CORRECTION MAP

OF SURVEY NO. 117 NO MONUMENTS SET THIS SURVEY

TO CORRECT THE BEARINGS AND DISTANCES OF THE NORTH AND WEST LINES OF THE SWI/4 OF SECTION 25, T. II S., R. 26 E., W. M.

MAP OF SURVEY NO. 670

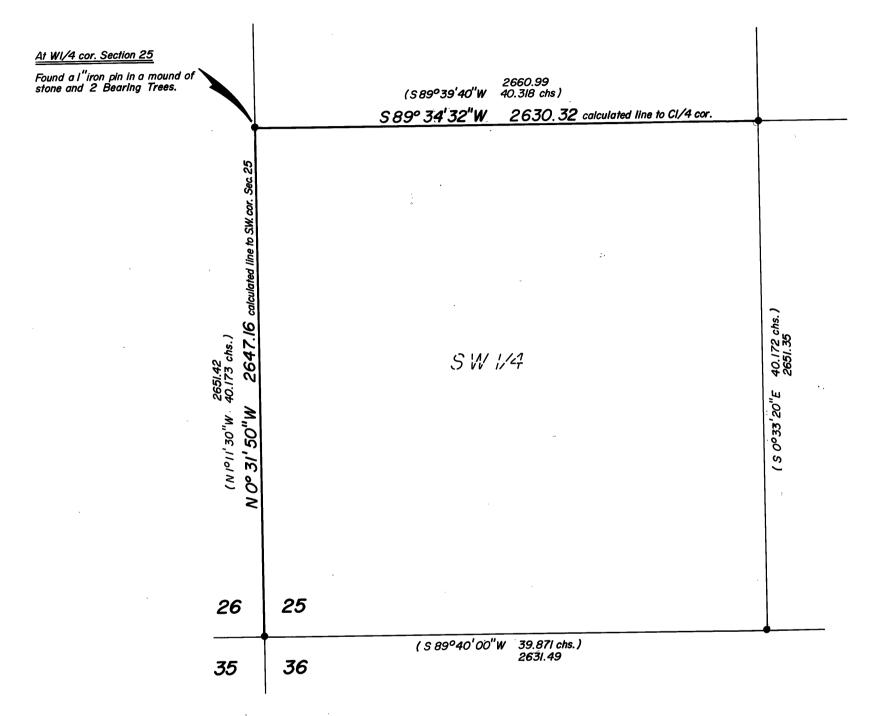
NARRATIVE: This map was prepared to correct the bearing and distance for the West line and the North line of the SW 1/4 of Section 25, T.IIS., R. 26 E., W.M.; as shown on Map of Survey No. 117.

> I recently discovered that I had made a field note reduction error in Survey No. 117 which affected the calculated position of the West 1/4 corner of Section 25.

> I have recalculated for the West and North lines of the SW 1/4 of said Section 25 and have shown the new courses and distances on this map.
